FEDERAL AID PROJECT
PROJECT NO.
CSJ: 0610-03-095
**TITUS COUNTY
IH 30**

FOR WORK CONSISTING OF CONSTRUCTING WEIGH STATION AND RAMPS

60% PLANS

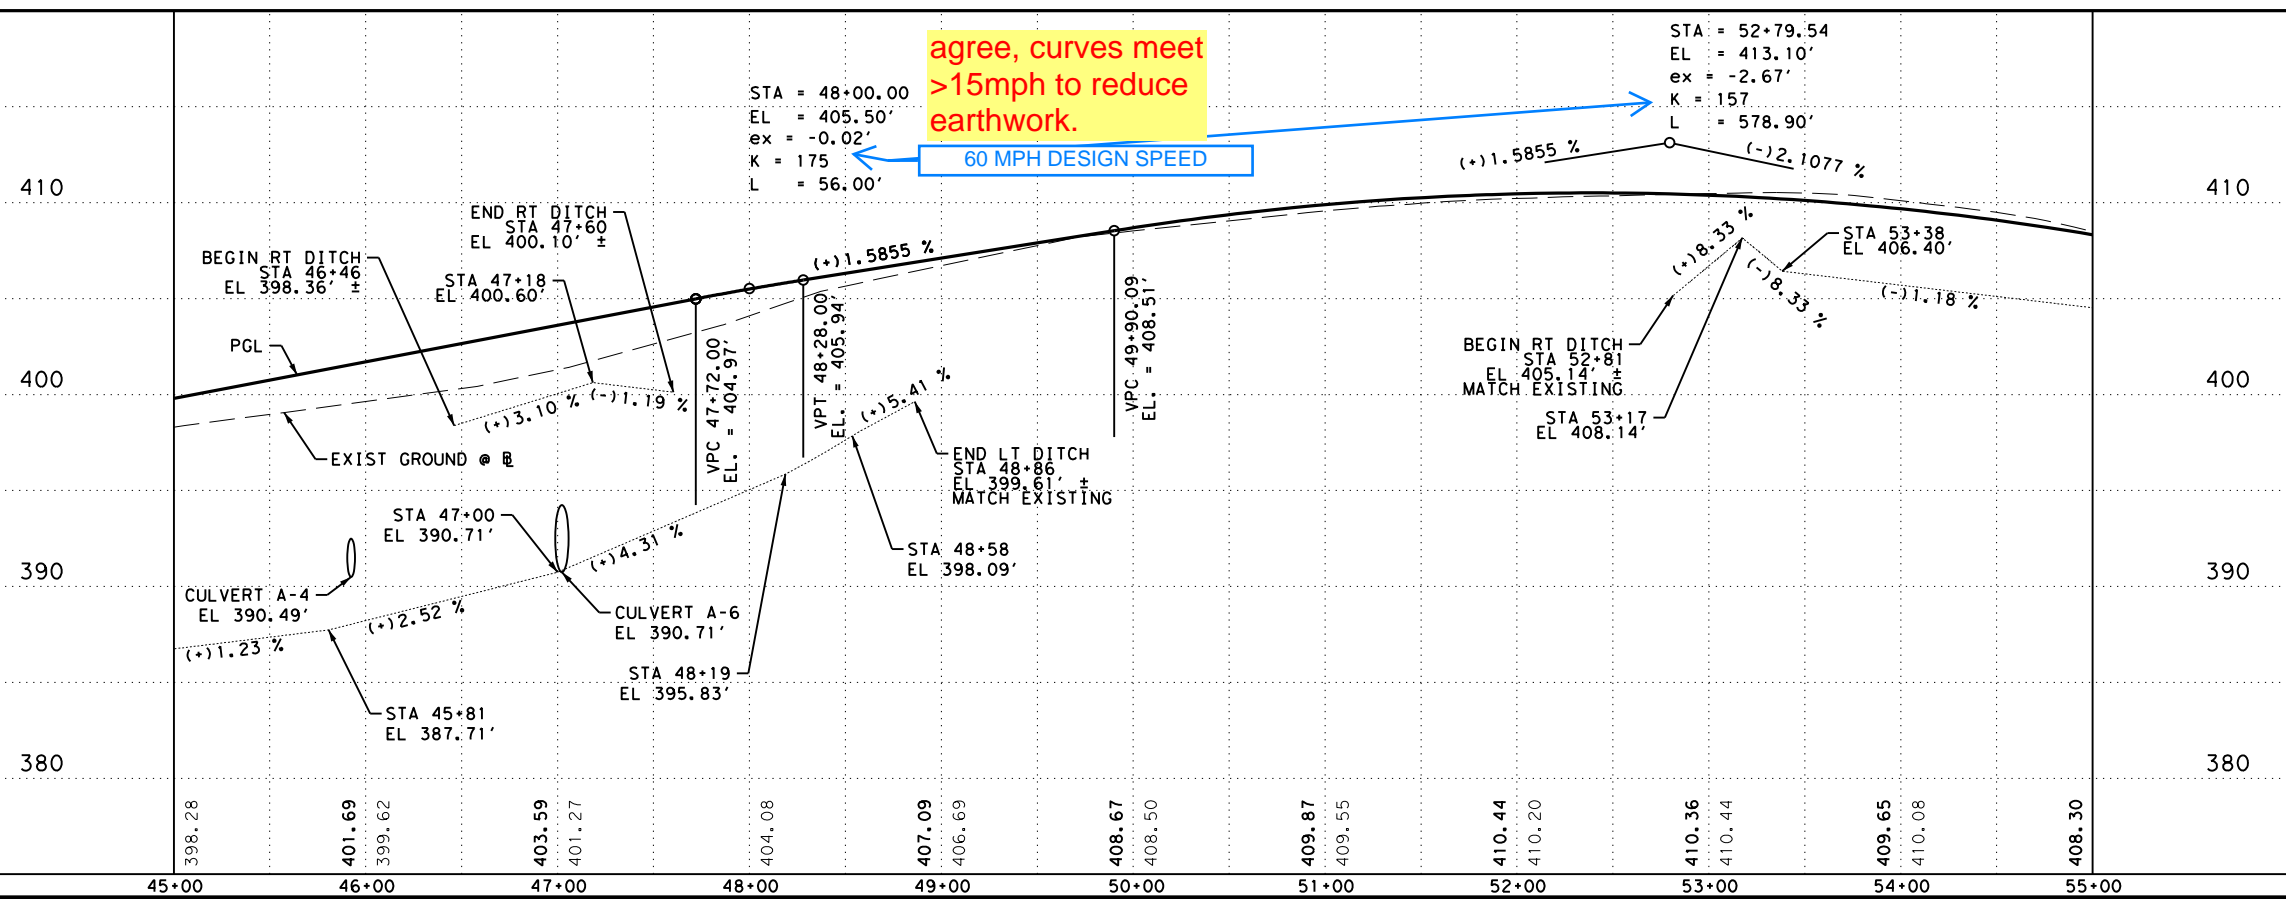
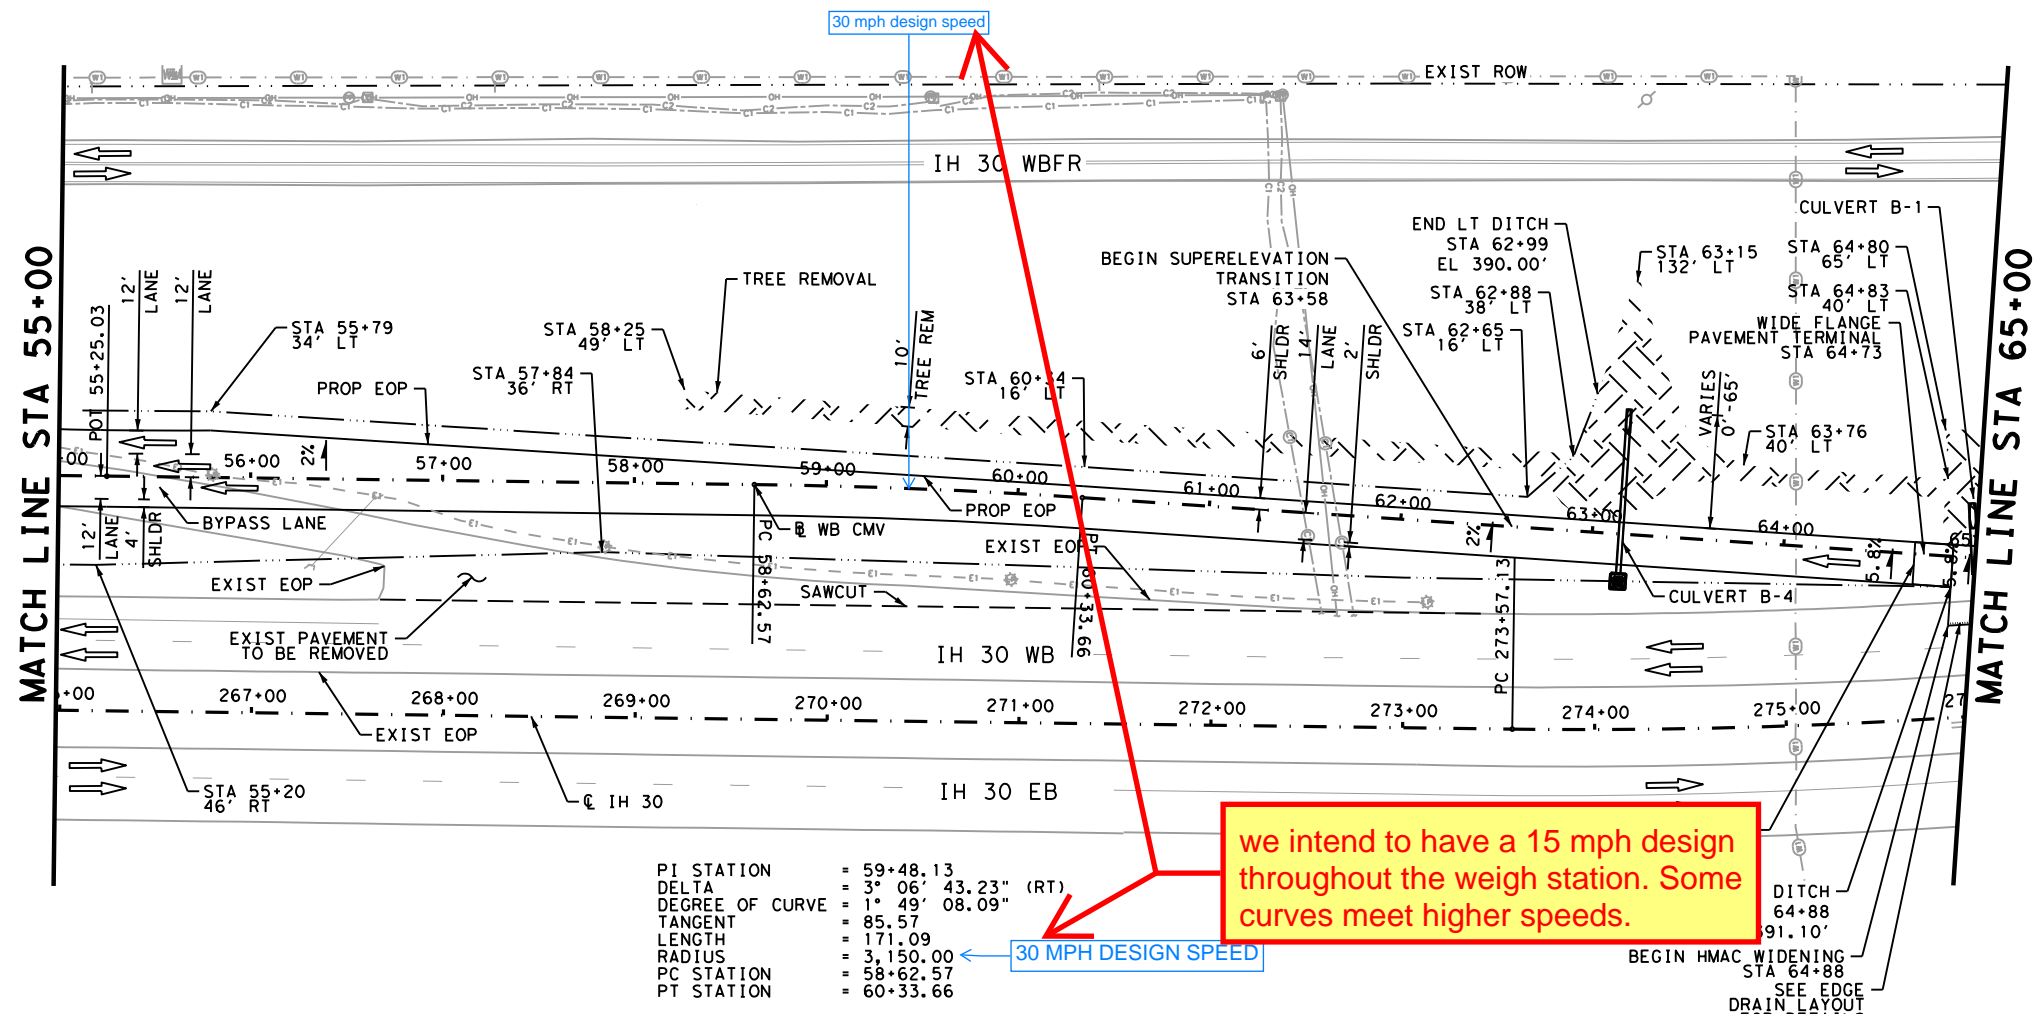
Hard to read text

text removed with redesign

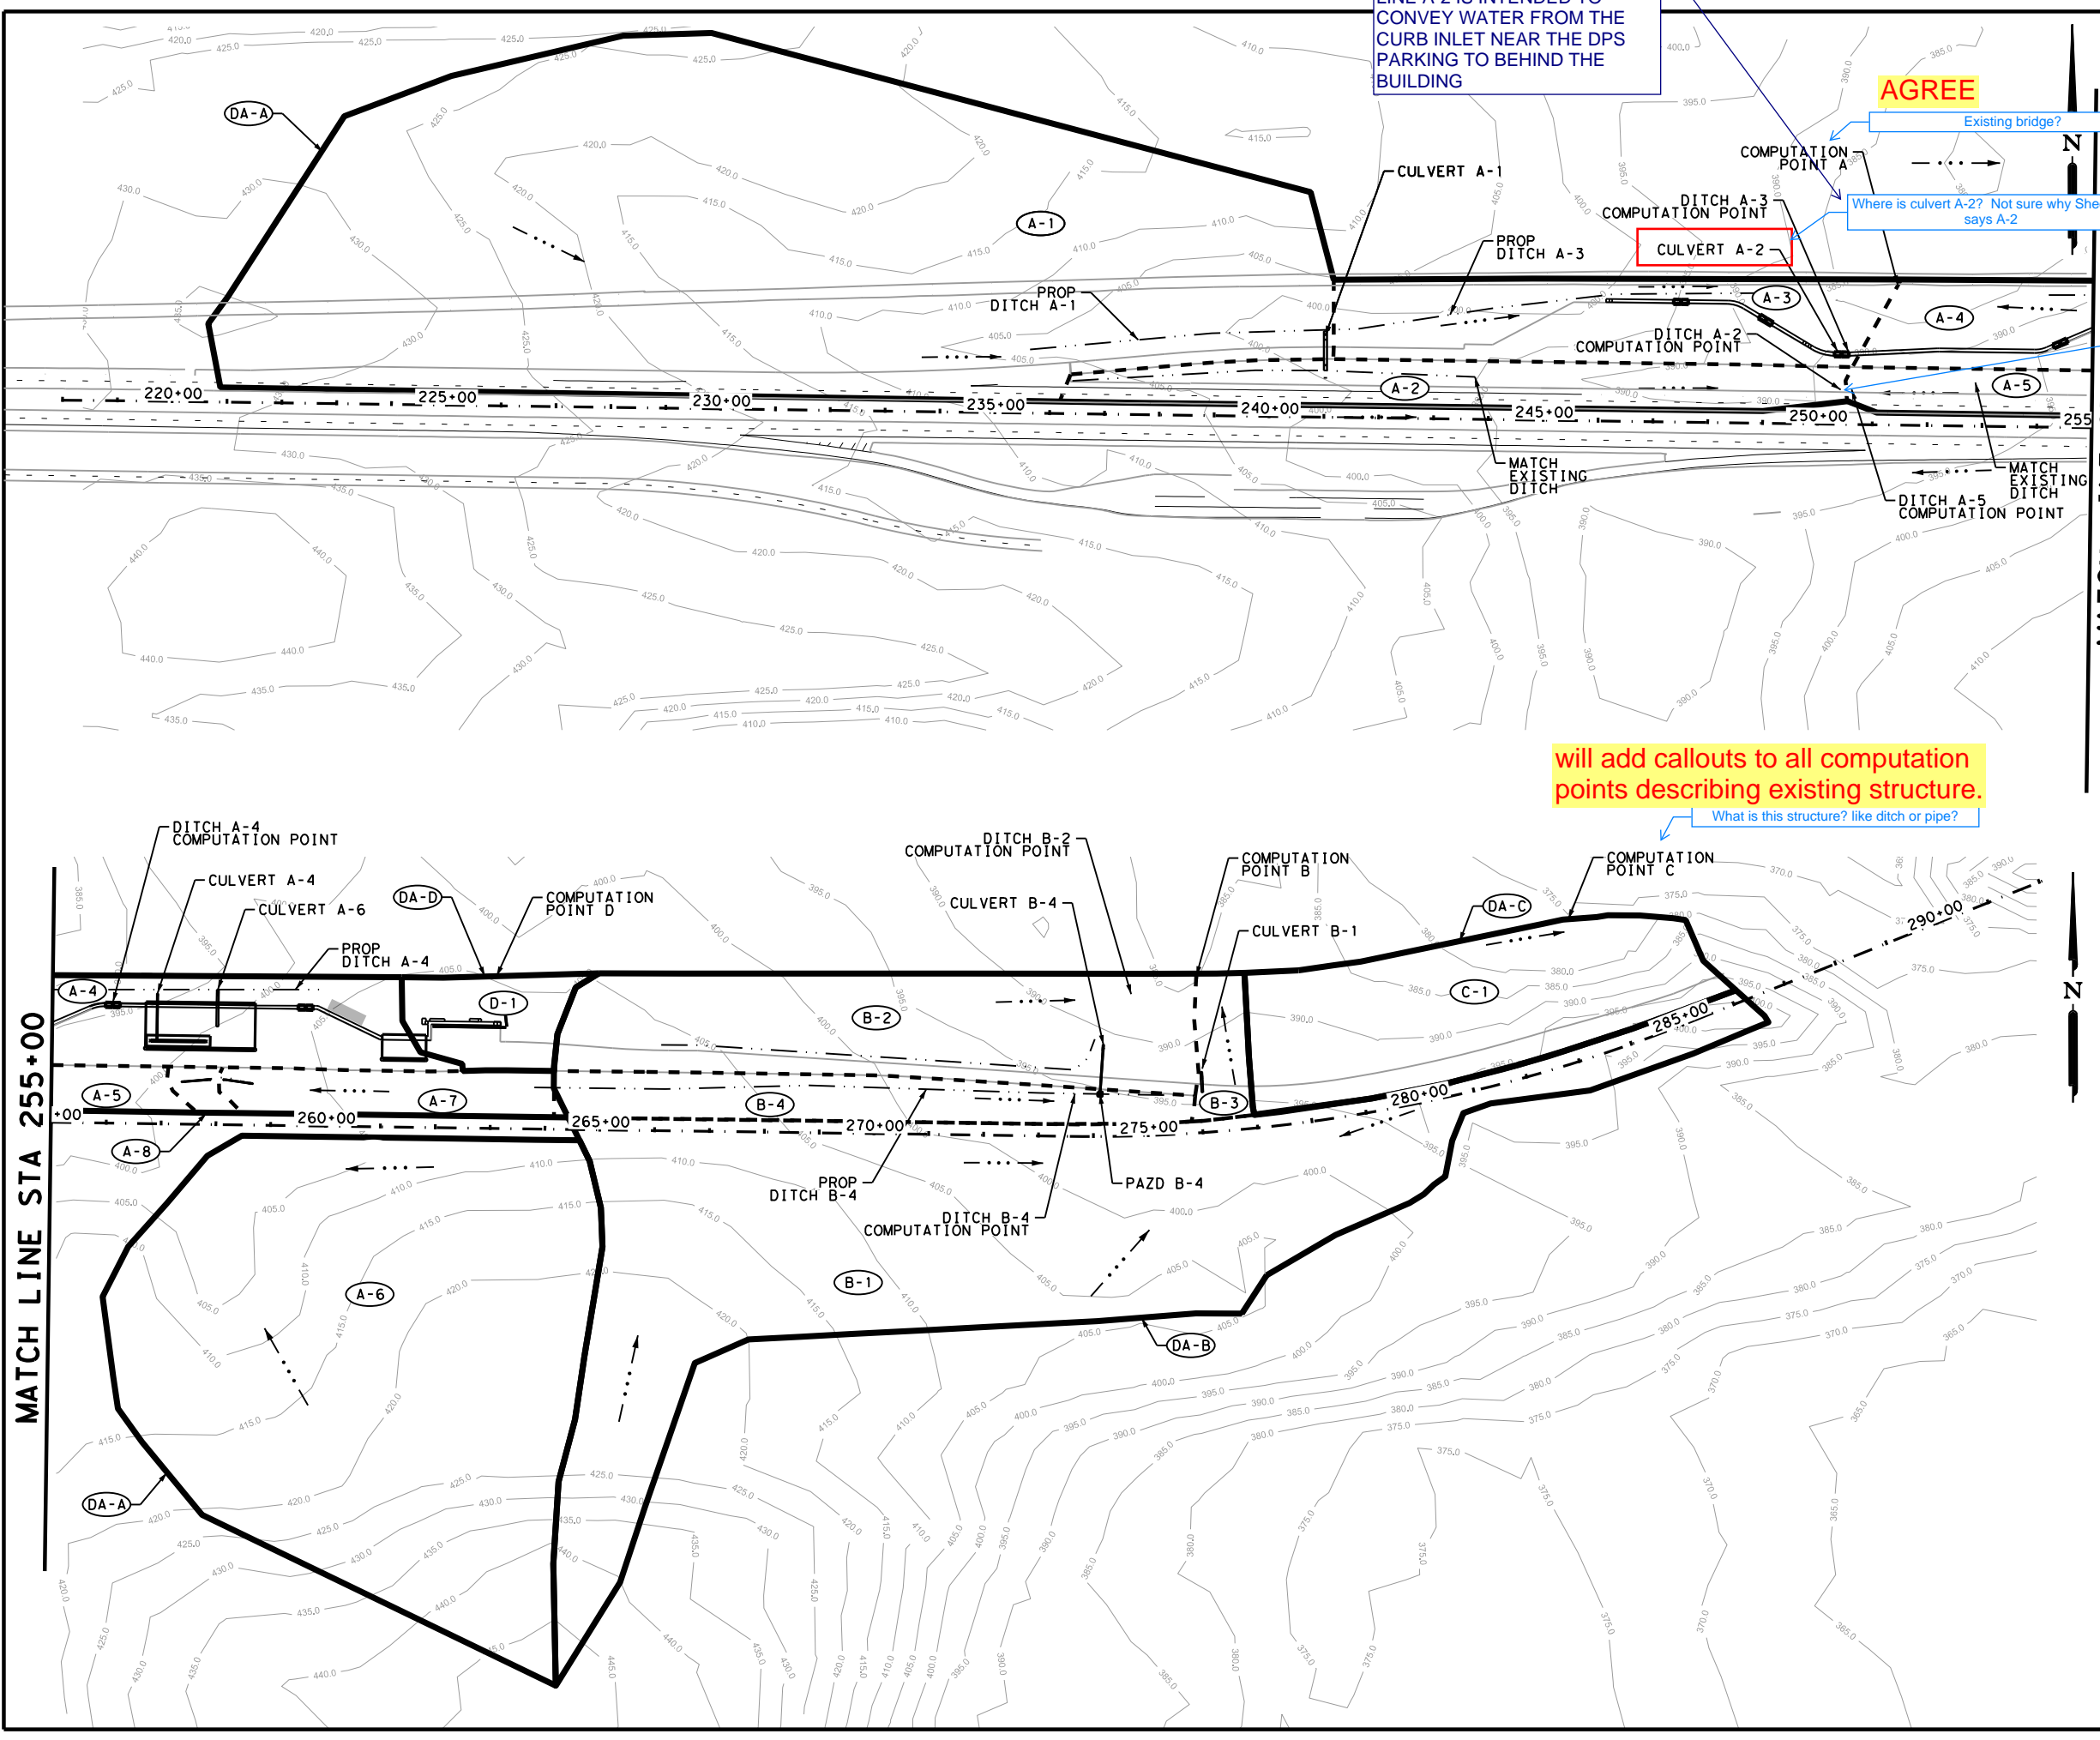
We should be checking freeway and frontage road hydraulics for proper Q's

agree, 10yr meets freeway criteria

**WB IH 30 CMV STATION
 CULVERT A-1
 LAYOUT**

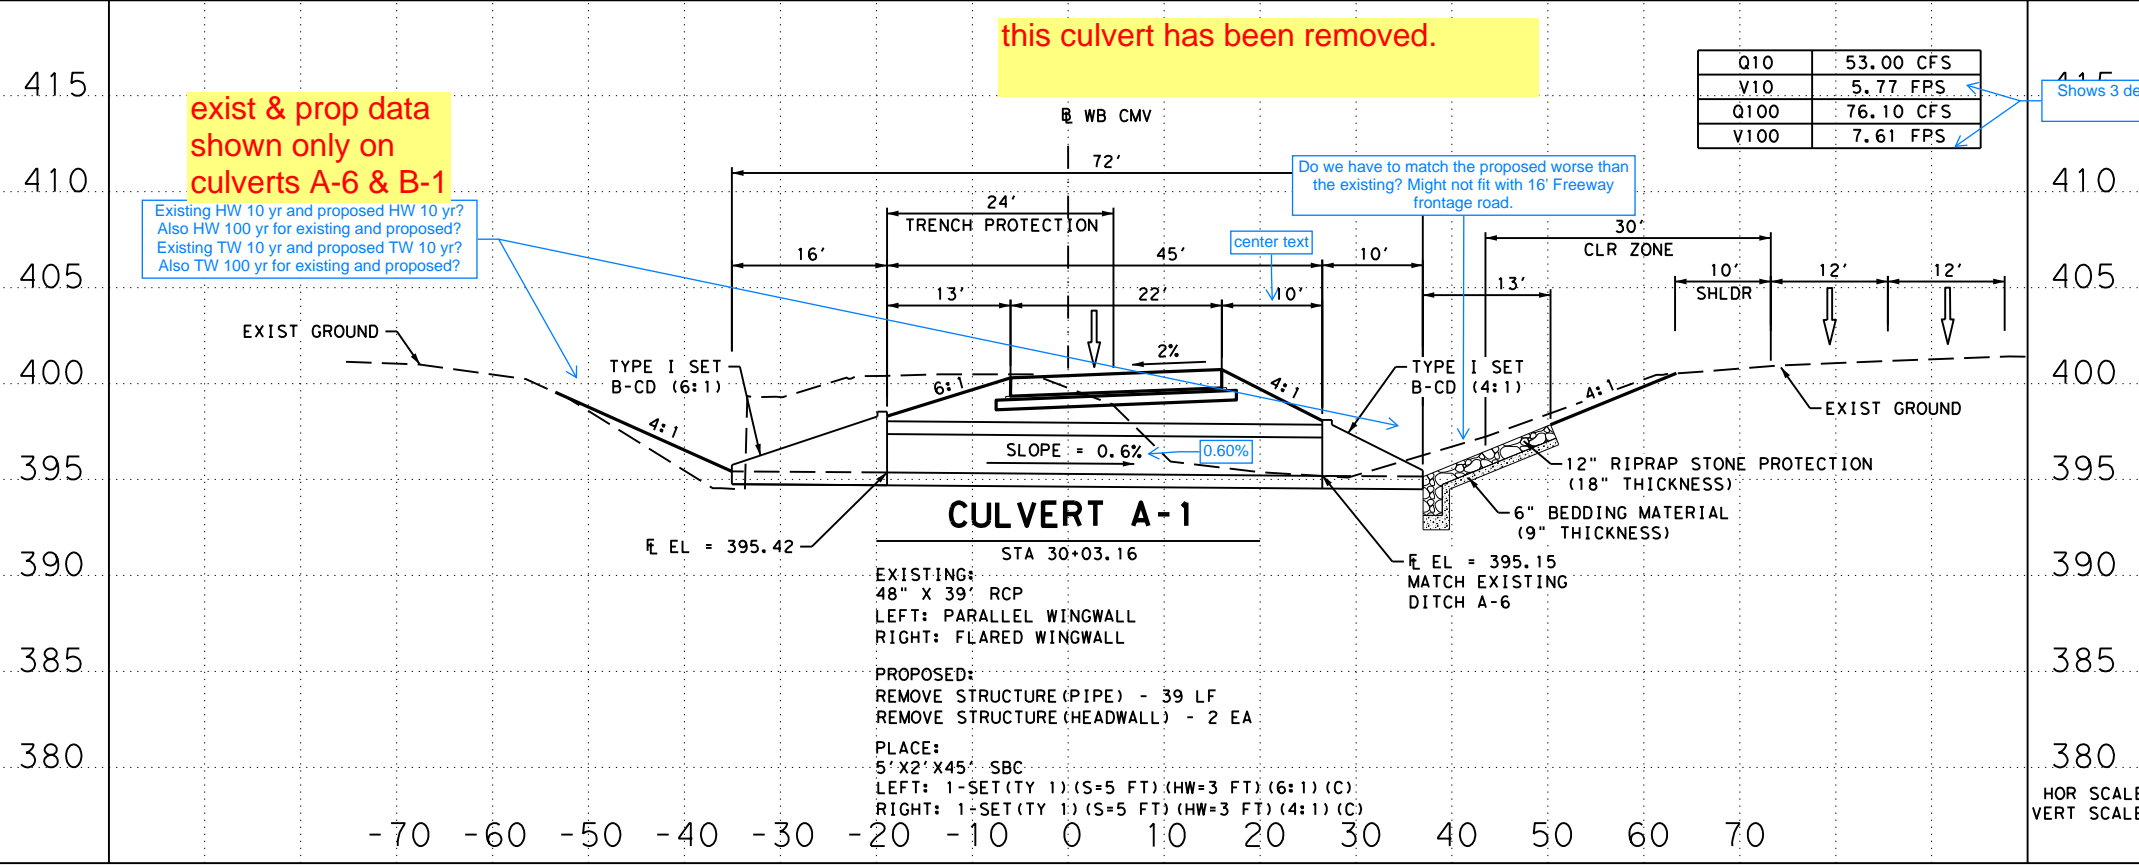
exist & prop data shown only on culverts A-6 & B-1
 Existing HW 10 yr and proposed HW 10 yr?
 Also HW 100 yr for existing and proposed?
 Existing TW 10 yr and proposed TW 10 yr?
 Also TW 100 yr for existing and proposed?

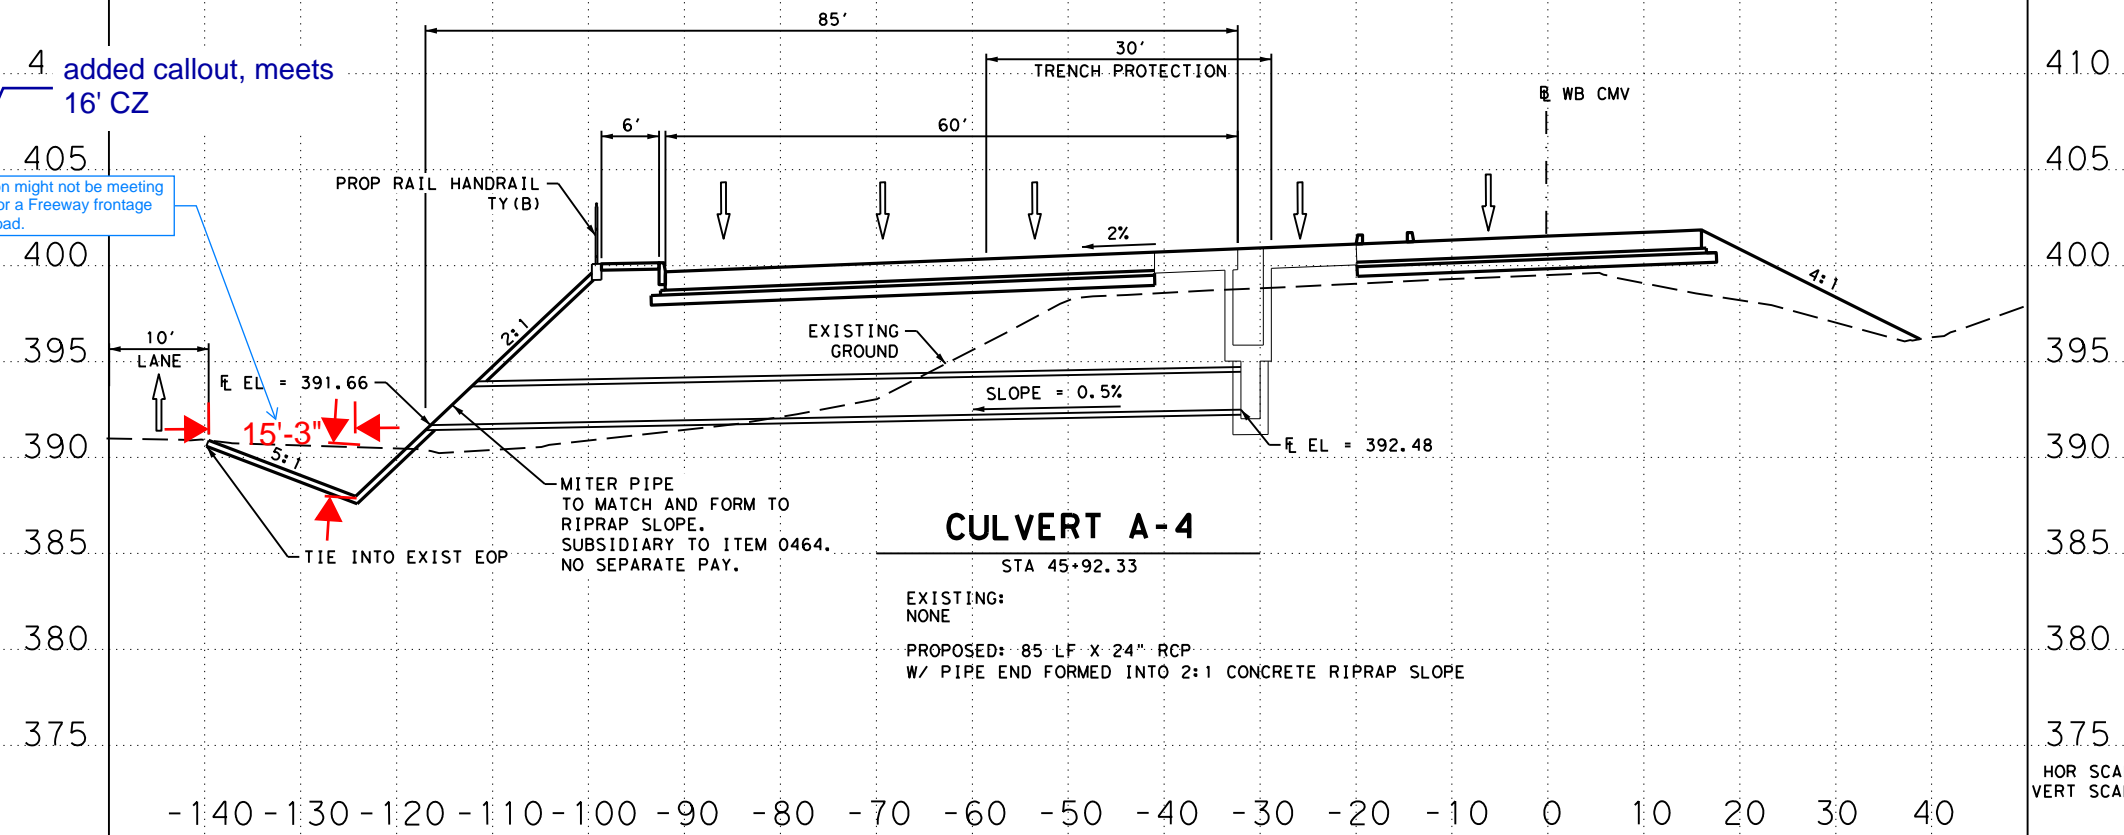
Looks like this location might not be meeting the 16' clear zone for a Freeway frontage road.

4 added callout, meets 16' CZ
